Project Name:	Mountain Valley Pipeline	Inspector:	Matthew Grant
Inspection Date:	Wednesday, August 30, 2023	Project Contact:	Brian Clauto
Spread I: Franklin	Sta 14062+17-14131+28 AR FR 309	Weather:	Wet

FIELD INSPECTION PHOTO LOG

Figure 3: Sta 14071+69, CWD not built to current specs.

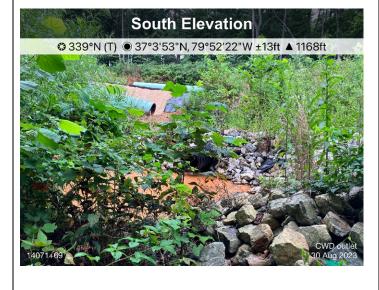
3.	Areas of o	ffsite s	sediment deposition ob	serve	d?				\boxtimes		
■ Comments: Inspected the following resources: S-EF48, S-KL41 Routine Maintenance: (72-Hour Deadline from Notification) - Sta 14071+69 Clean water diversion not per current specifications, build to current specs. - Sta 14111+00 to 14112+00 pipe coating material on ground, remove overspray and dispose of properly. - Sta 14110+00 pipe coating material on ground, remove overspray and dispose of properly. - Sta 14100+69 CFS requires maintenance. - Sta 14100+09 to 14102+00 pipe coating material on ground, remove overspray and dispose of properly. - Sta 14009+00 pipe coating material on ground, remove overspray and dispose of properly. - Sta 14000+09 to 14102+00 pipe coating material on ground, remove overspray and dispose of properly. - Sta 14081+00 pipe coating material on ground, remove overspray and dispose of properly. - Sta 14081+00 water flow path blocked on waterbar. - Sta 14081+00 pipe coating material on ground, remove overspray and dispose of properly. Ineffective Controls: (24-Hour Deadline from Notification) - Sta 14104+91 CFS requires maintenance. Recommended Corrective Action: Maintain and install all controls per the approved PSS&S. Deadline: Various - See Comments The recommended corrective action deadline date applies to all conditions noted on this report unless otherwise noted. If listed condition(s) currently constitute non-compliance and/or corrective actions are not completed by the deadline, other enforcement actions may be issued to the entity responsible for ensuring compliance on the above project.
